# SKEP III Home Office Support Site Visit Report

Consultant	Wahib Medanat Consultant Engineer	Rep No.	13-27072022
Contractor	Derar Saraireh & Sons for Engineering & Contracting	Tender No.	(11/2019/USAID/SKEP/3/S) Schools for a Knowledge Economy Project (SKEP) - Phase (3) Package (1, 2)
Site Name	Khadija Bint Khwailed Basic Mixed School- Shouna Janoubia	Day/ Date	Wed. 27/07/2022
Duration of Project	450 Calendar Days	Total Project Budget	9,789,417.840 JD

(Figure: 10)

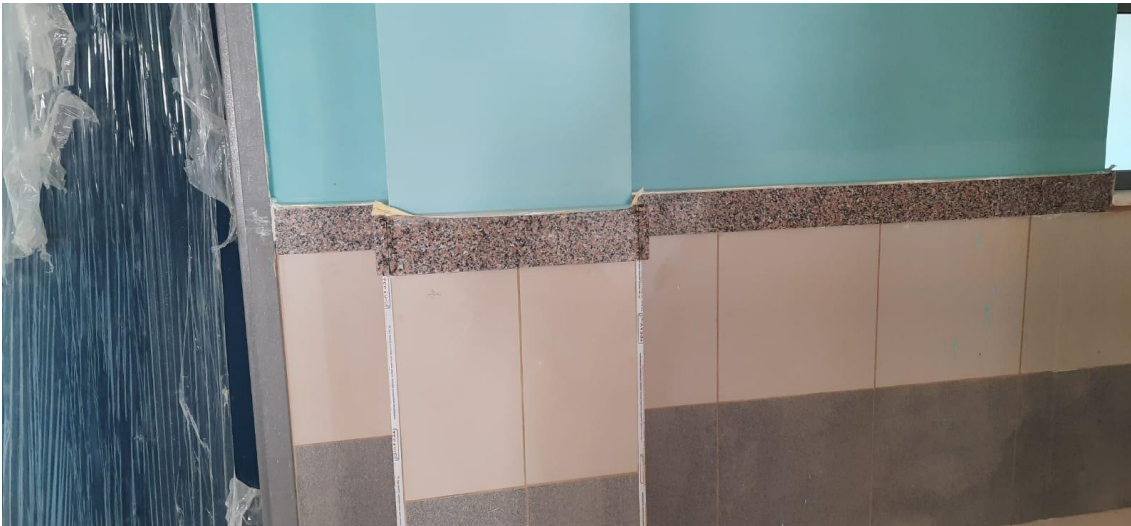
The team previously observed that the Contractor has installed interlock tiles in an unacceptable way with regard to the architectural details and approved shop drawings

The Contractor has retiled the interlock tiles according to the architectural details and approved shop drawings
